DRAINAGE SUMMARY

PROJECT: MAUNALOA HIGHWAY, REPLACEMENT OF CULVERTS BETWEEN
MAUNALOA VILLAGE AND KAUNAKAKAI - PHASE II
PROJECT NO. RS-0460(3)

STATE OF HAWAII
DEPARTMENT OF TRANSPORTATION
HIGHWAYS DIVISION

Replacement of Culverts bet. Maunaloa
Village and Kaunakakai - Phase II

DRAINAGE SUMMARY

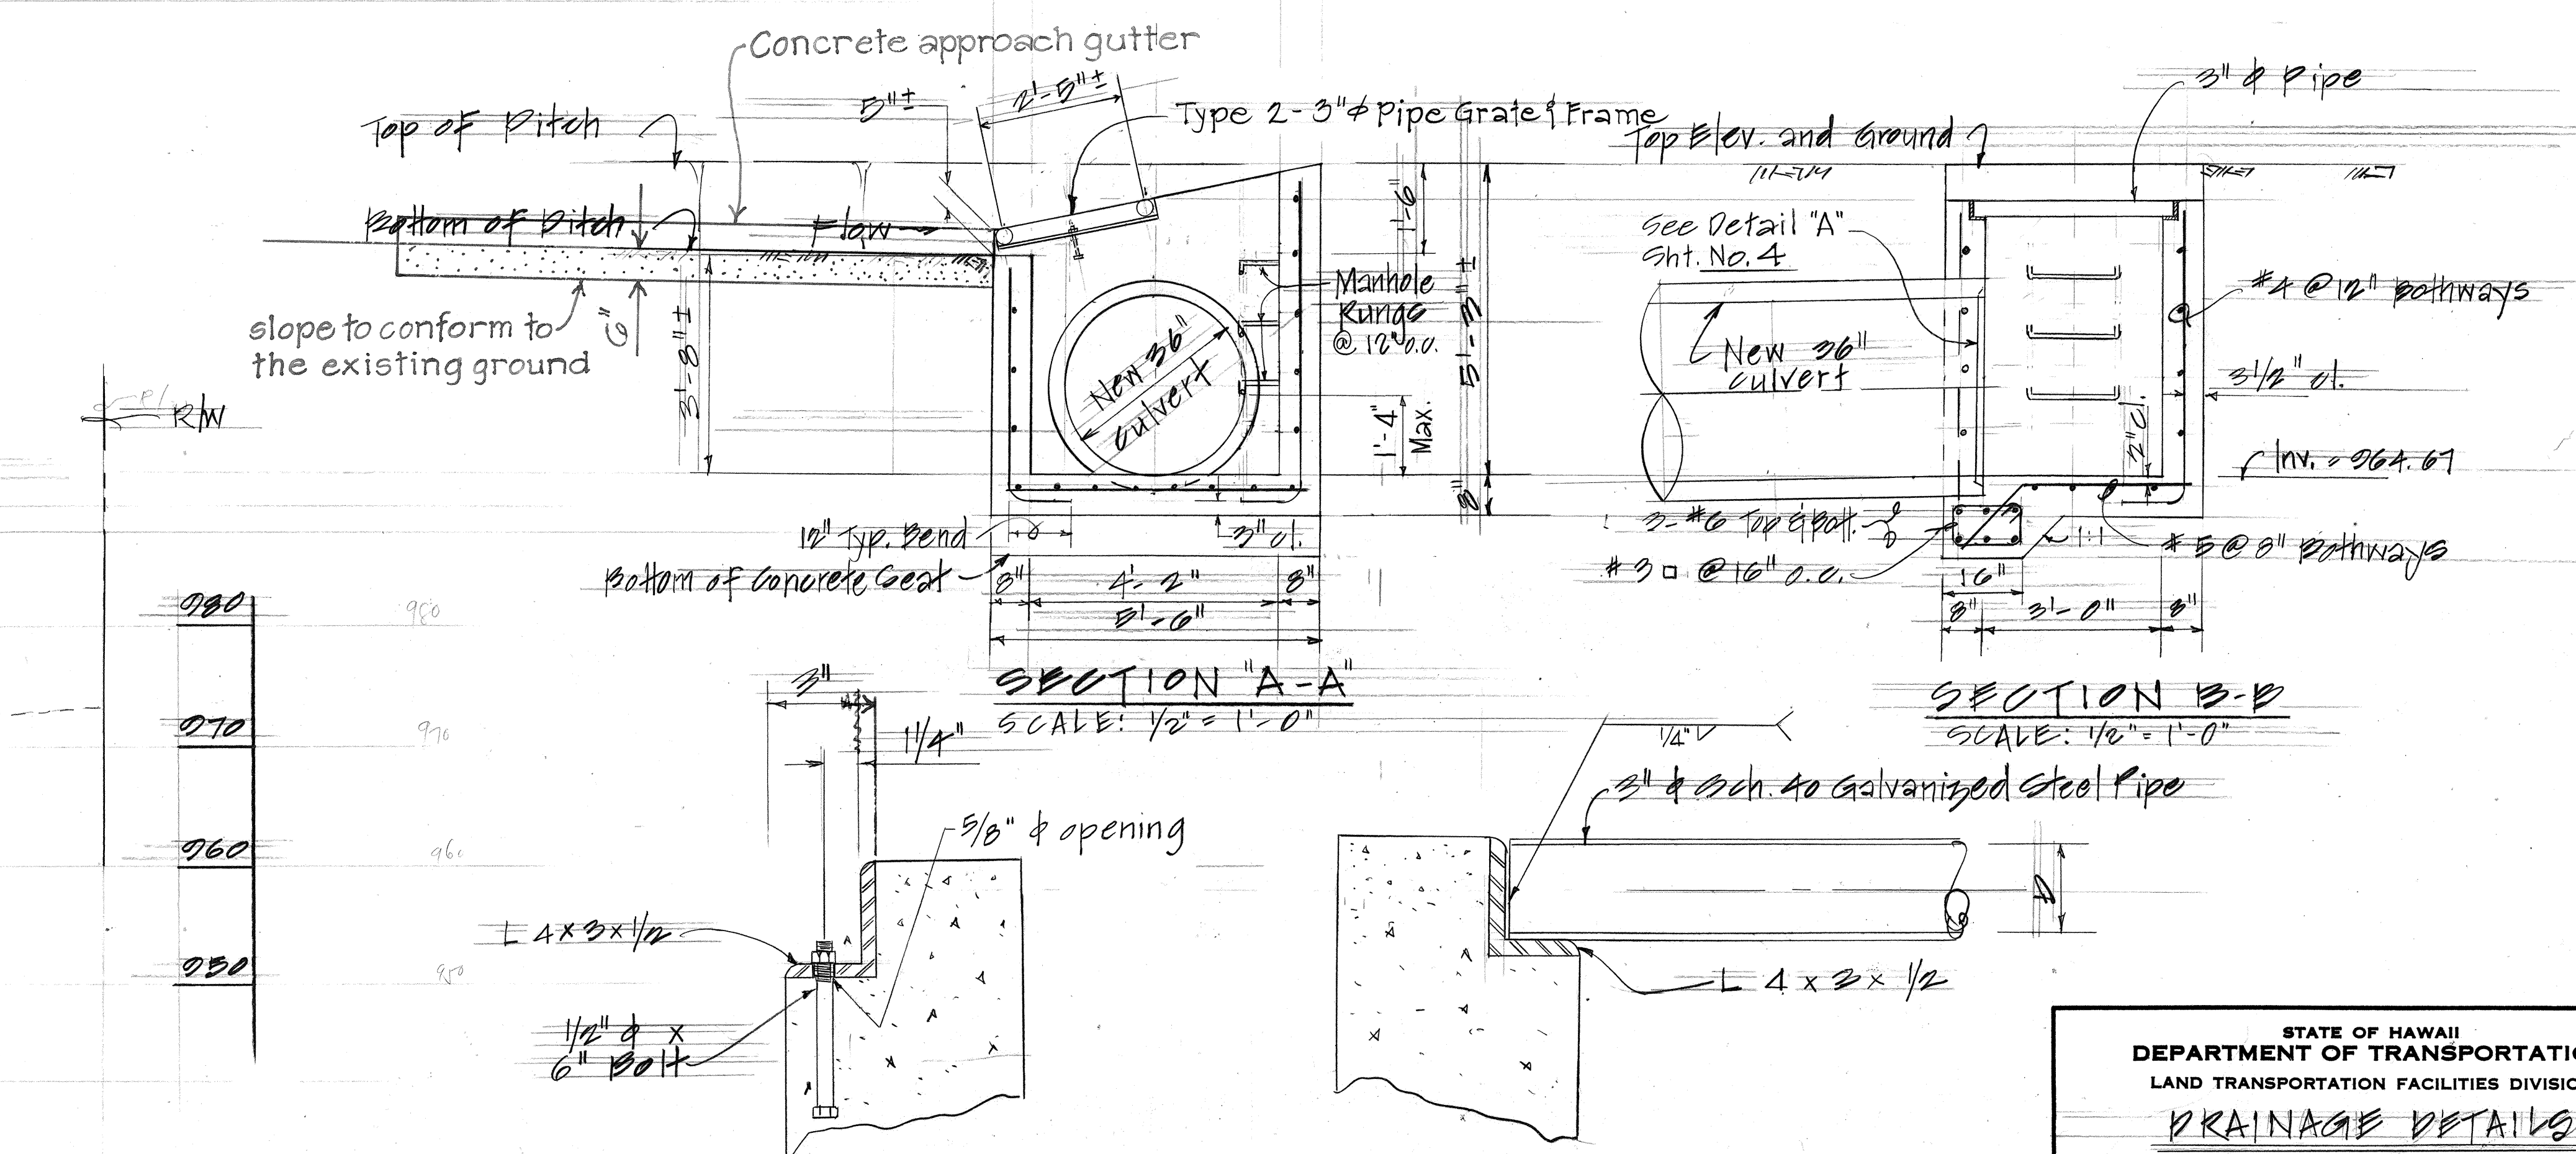
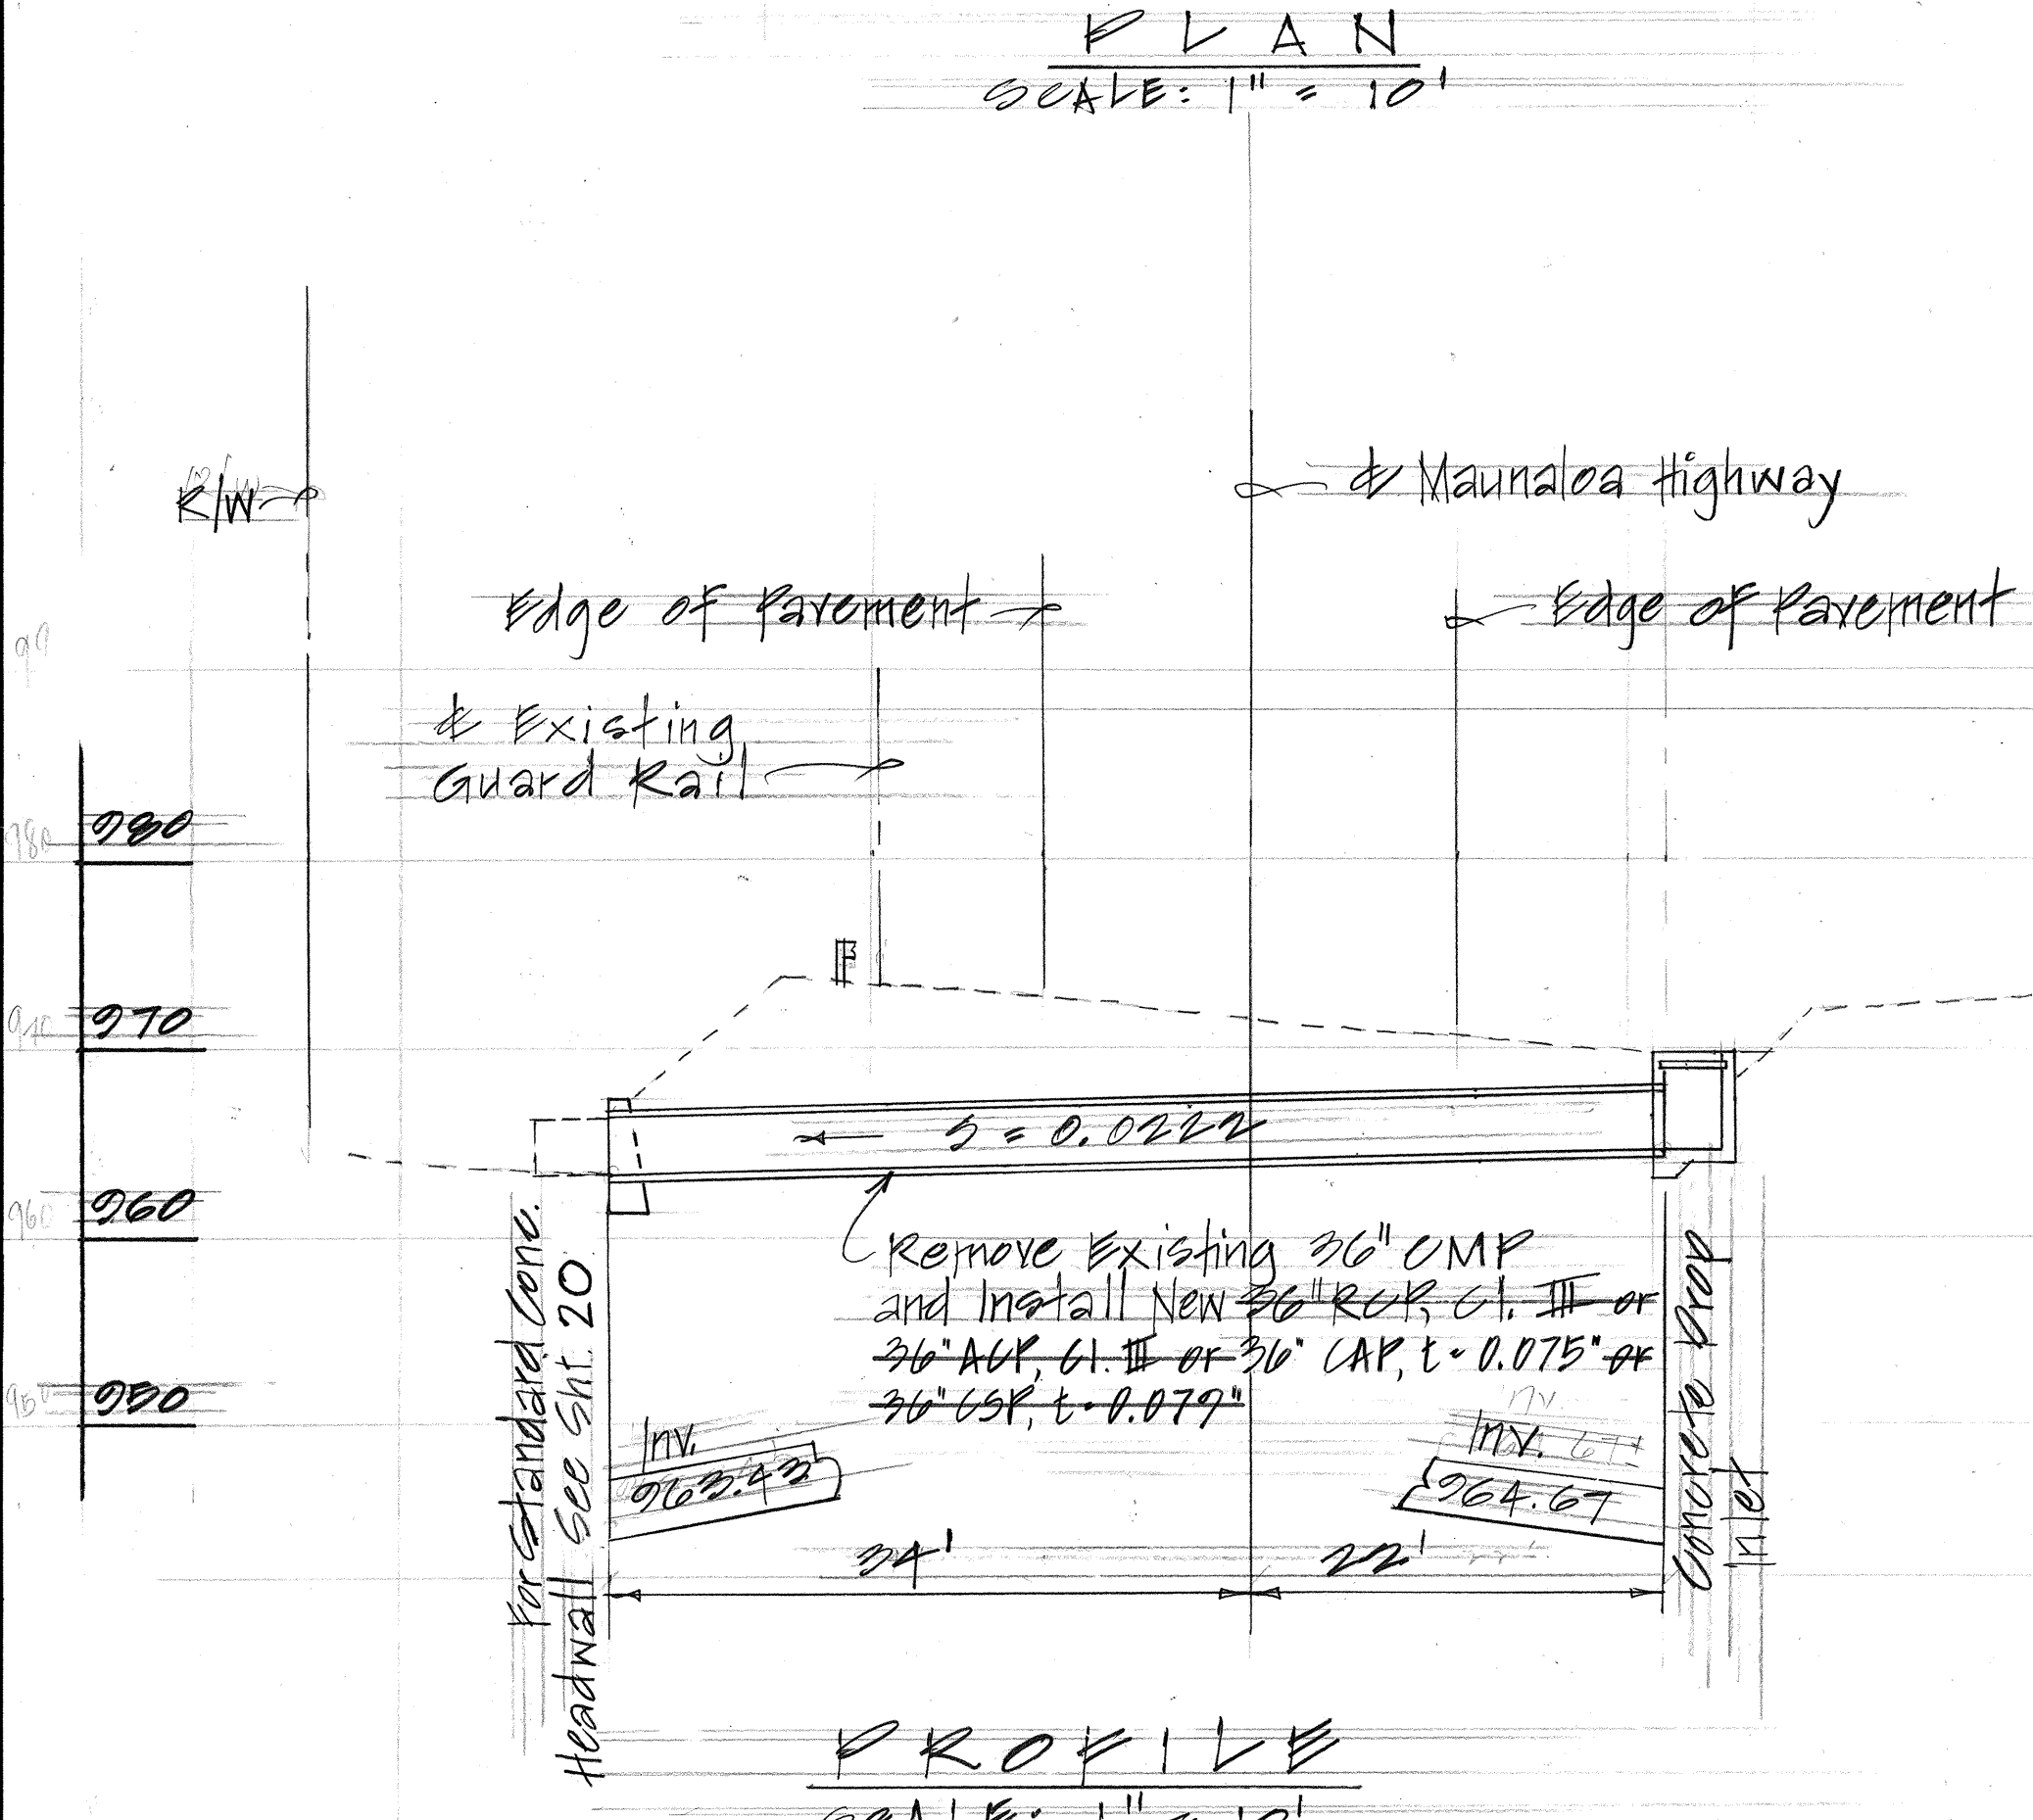
10/23/84 Per Addendum No.1
Changed the following culverts from:
42" CAP, t=0.105" to 42" CAP, t=
0.075" (3x1), 60" CAP, t=0.135"
to 60" CAP, t=0.075" (3x1), and
60" CAP, t=0.164" to 60"
CAP, t=0.075" (3x1)
DATE REVISION
